June 1, 2011 Planning Commission Agenda Item 6.b (601 Glendome Circle);

Update to April 20, 2011 Staff Report

Case File Number: CMD09-140 **April 20, 2011**

> To install six (6) telecommunication antennas on an extension to the top of an existing PG&E tower, three (3) antennas to the

ATTACHMENT A

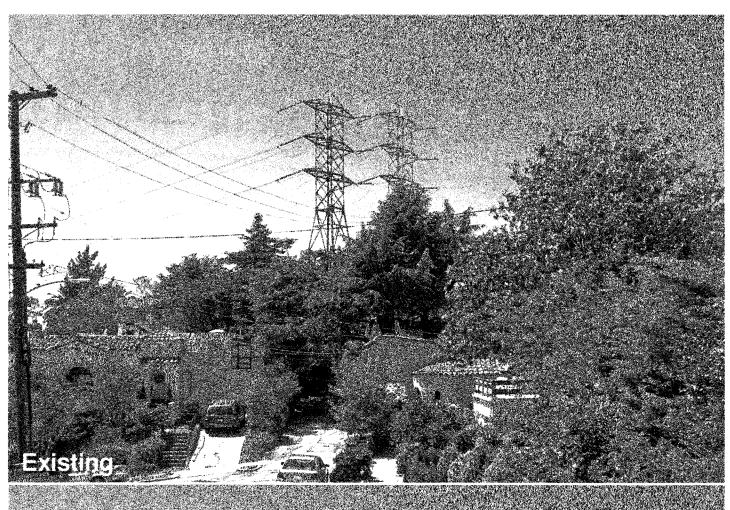
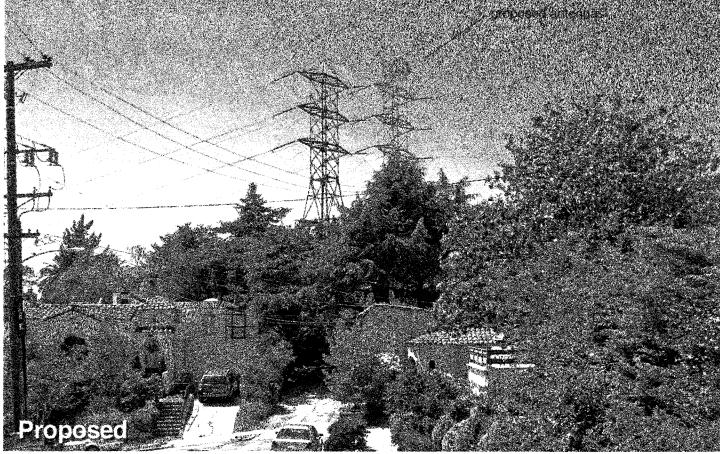
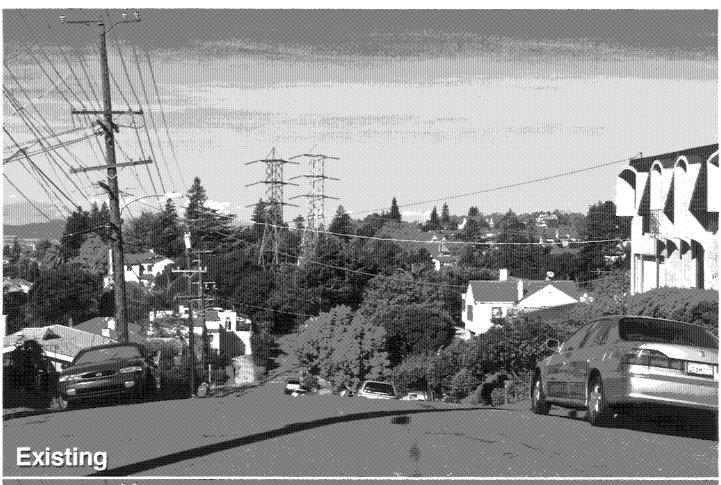
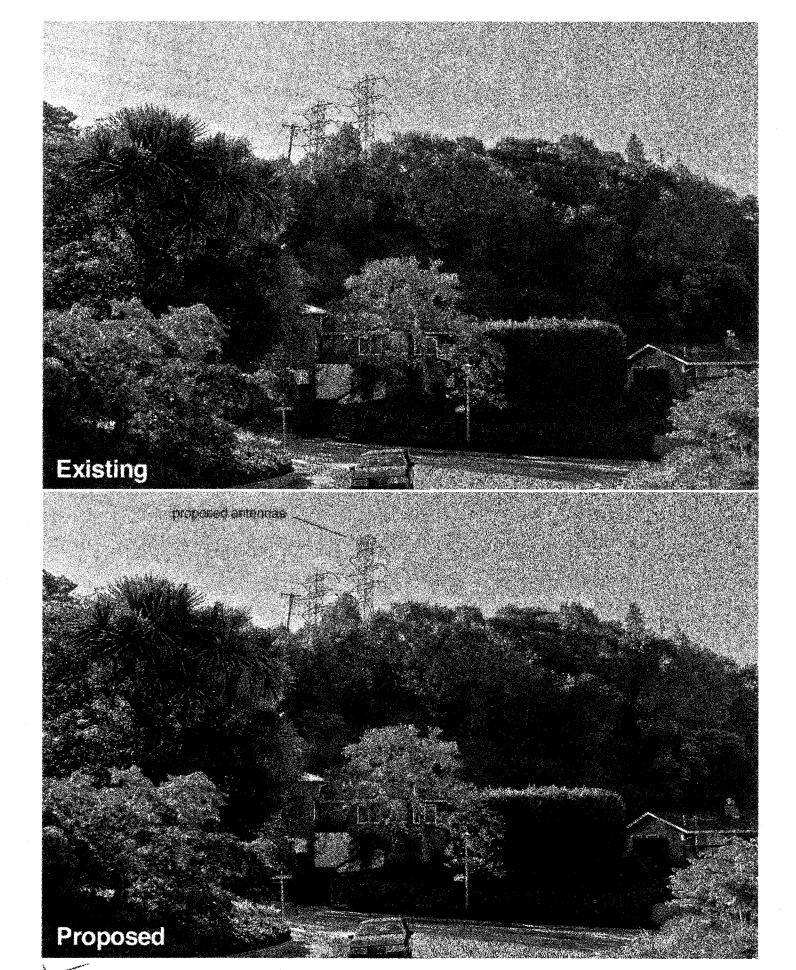
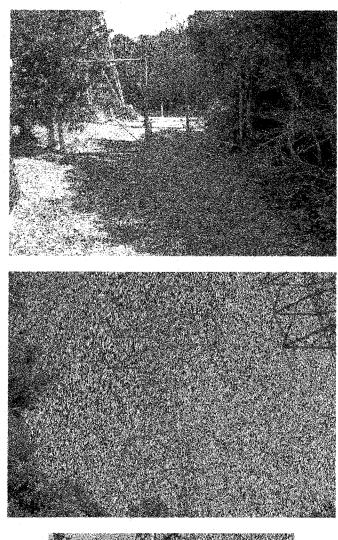
The proposal is for a new unmanned wireless telecommunication facility located on an exiting PG&E tower with installation of six (6) telecommunication antennas on an extension to the top of the tower, three (3) antennas to the legs of the tower, and associated equipment shelters on the ground below the tower. The proposal does not attempt to visually mitigate impacts the antennas will have on the surrounding residential neighborhood and will increase the visual impacts that the existing tower already presents. The residents currently have existing 85 foot high towers in direct view from the adjacent properties and by adding a 12 foot extension and antennas to the top and legs of the tower, greater visual clutter and unattractive mechanical devices in that view will only worsen the existing condition for the residents.

The proposal does not match the materials, texture and color of the existing PG&E Tower. They will appear to be visually prominent attachments to the structure that will not blend in or harmonize with the structure. The zoning regulations attempt to minimize the impact of antennas by screening, stealthing or texturing them to appear to be something other than what they are. This project does not attempt any of these methods and makes an already intrusive and atheistically unappealing facility worse in the process.
